ADDENDUM NO. 2

Reference: Student Activity Center Addition to the Stromberg Athletic Complex
Weber State University – Ogden, Utah
DFCM Project No. 12031810

Addendum 002

project:	WSU Stromberg Student Activity Center	**project no:**	12475
date:	2012-10-15	**no. pages:**	75
owner:	DFCM		
contractor:			
bid date:	2012-11-01	**bid time:**	12:00 pm

S123

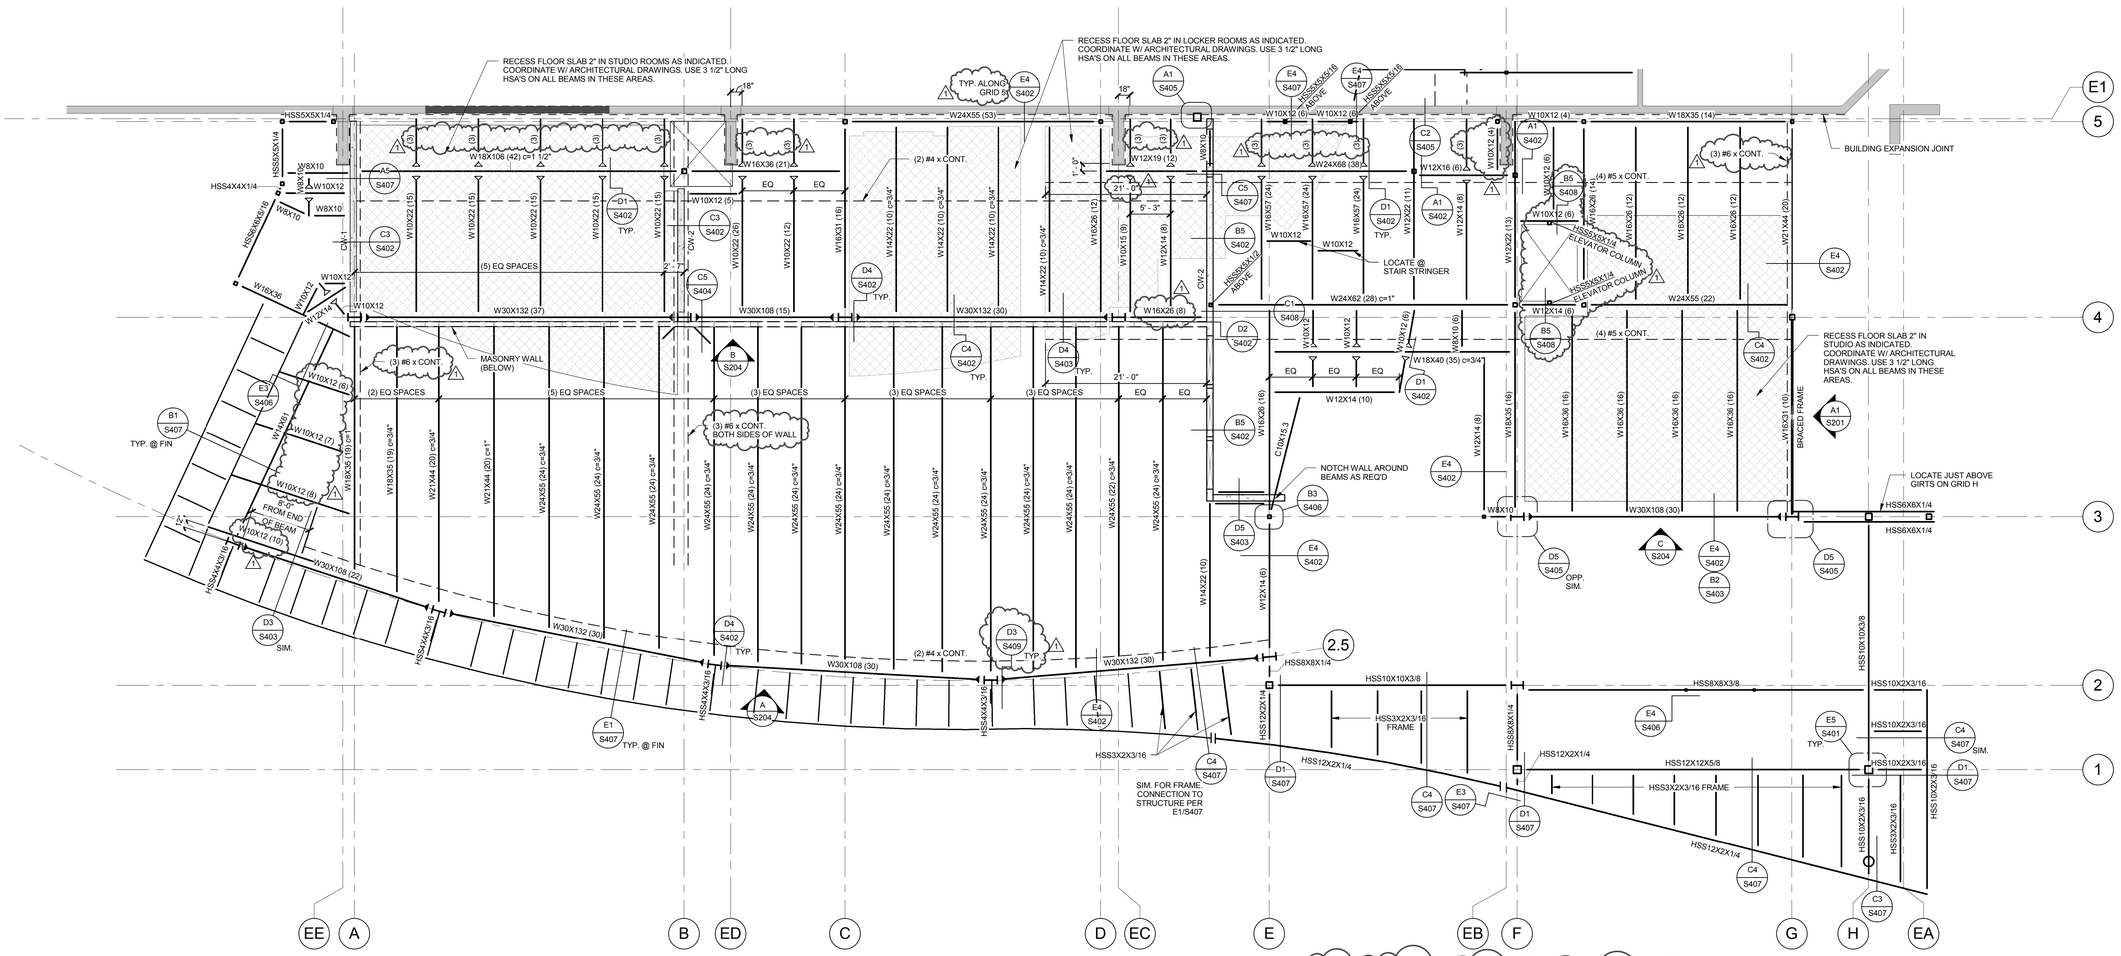
Sheet S123
-Floor framing note 5 has been revised.
-Floor framing note 14 is new.
-Rebar has been added to the floor plans as required for collection of seismic forces.
-Headed stud callouts have been added to the cantilevered beams.
-The steel beam on gridline 4 between EC and E has been revised.
-Detail callout D3/S409 has been added at 2.5 and C.5.
-Elevator support columns and the applicable detail have been added.
-The detail E4/S402 callout on gridline 5 has been revised to indicate that the bent plate occurs along the full length of gridline 5.
-A floor beam has been added at EB and 5.

S132

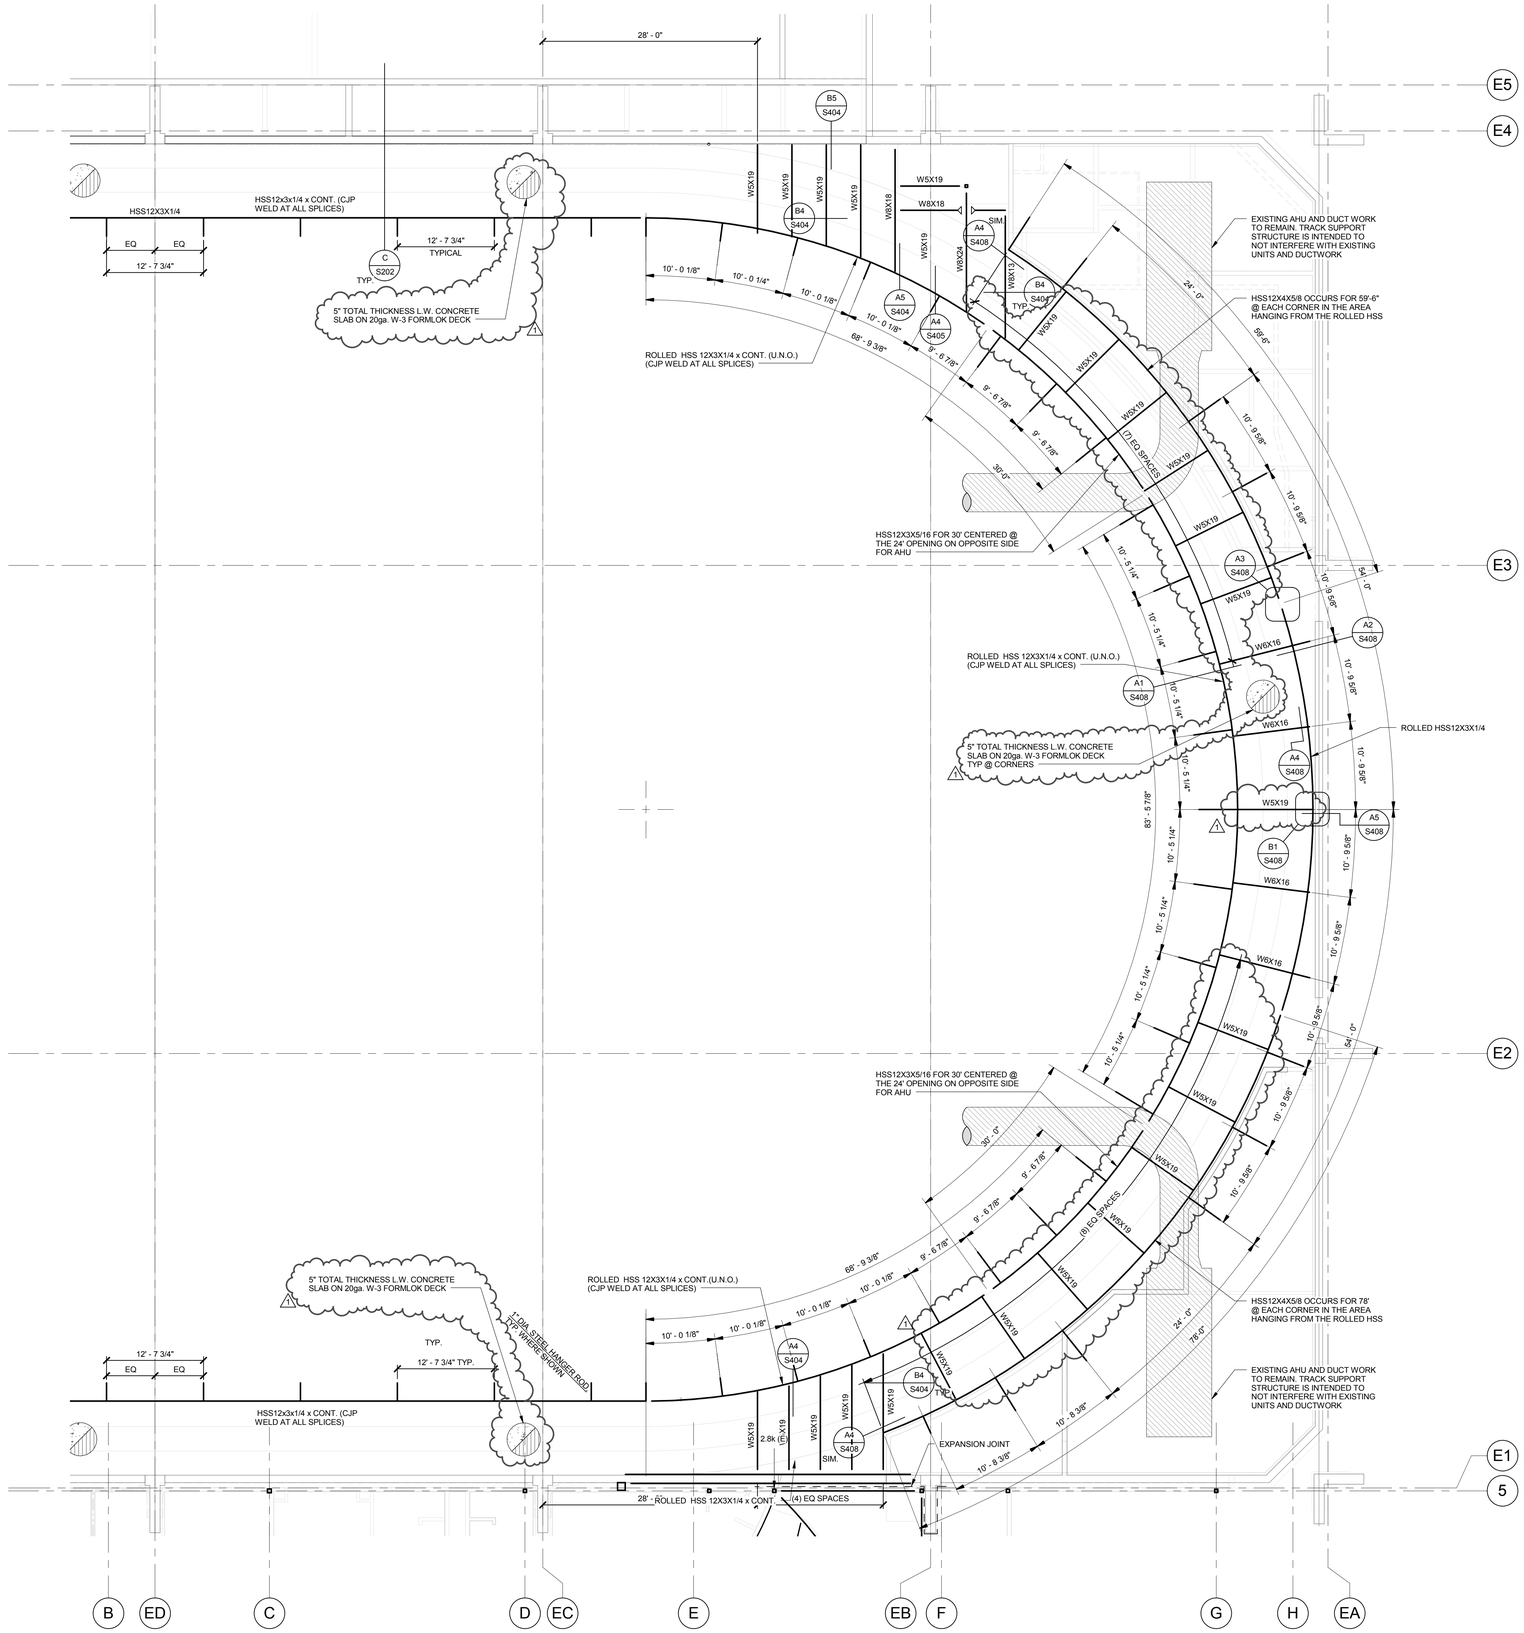
Sheet S132
- Track floor deck support members have been added and clarified at the corners.

S141

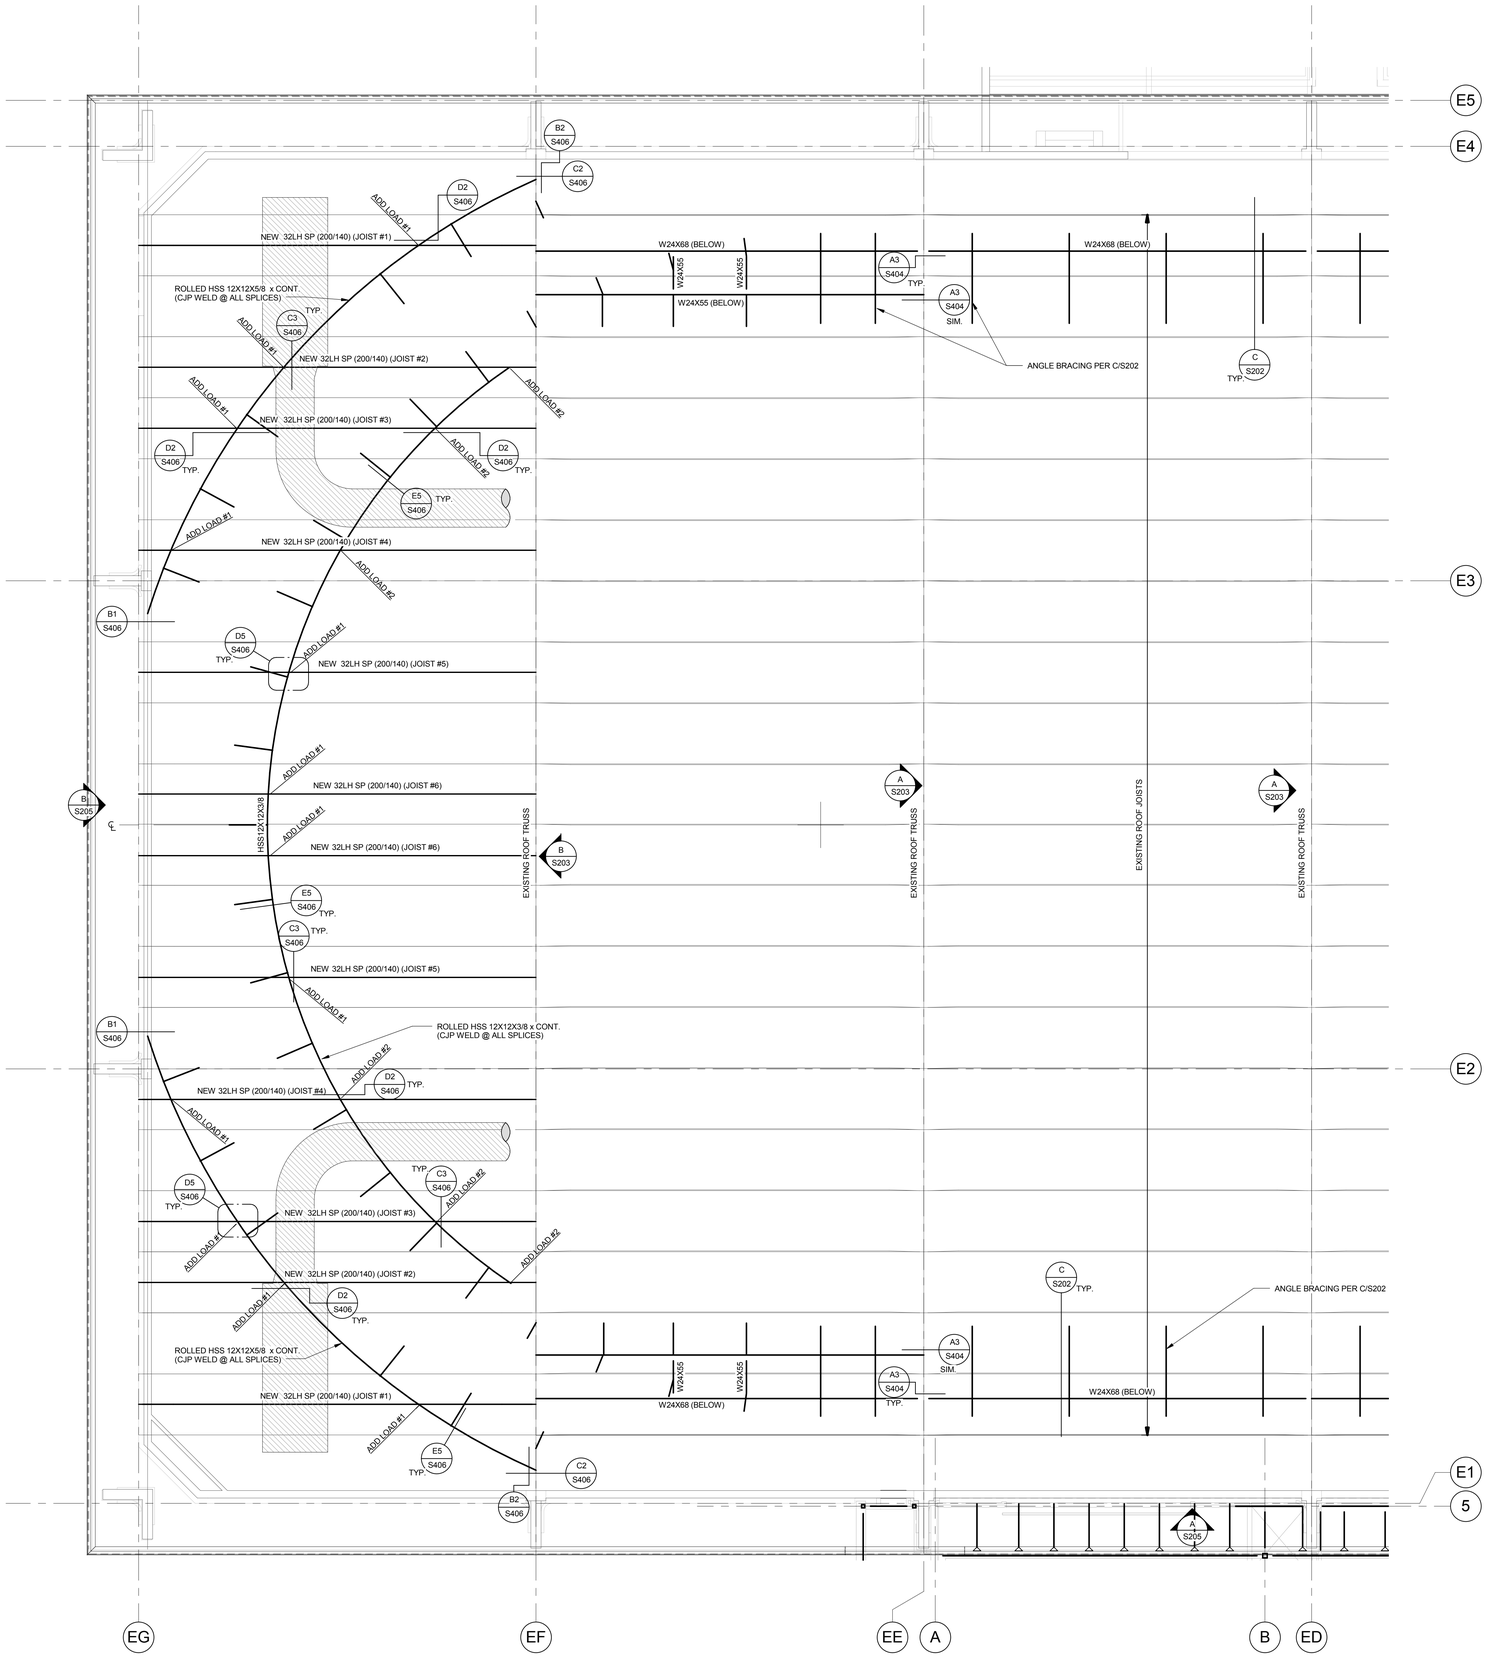
Sheet S141
-A note has been added referring to S141.1 for roof upgrades.

S141.1

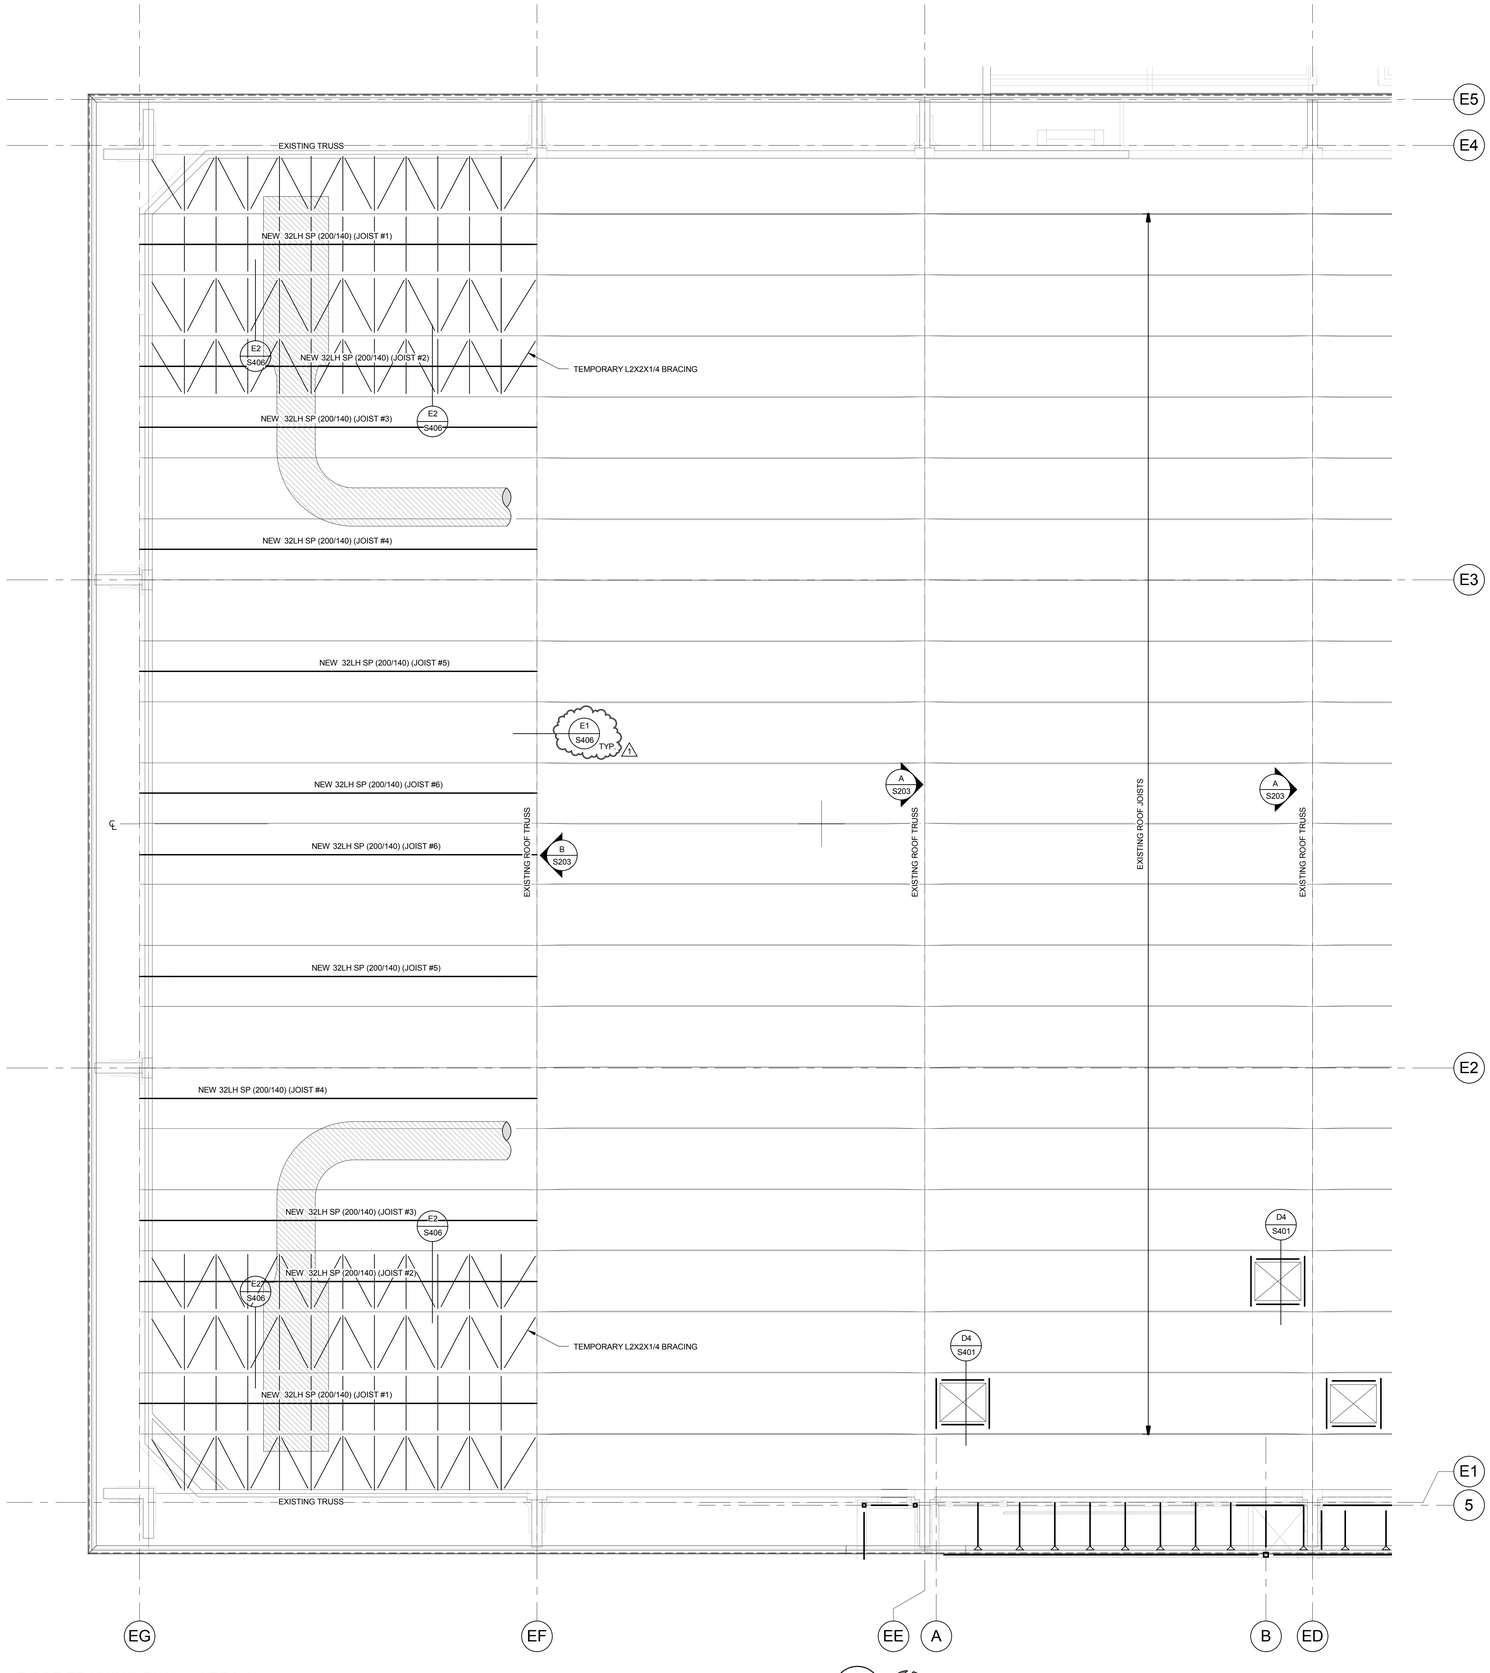
Sheet S141.1
-A detail cut has been added along gridline EF.
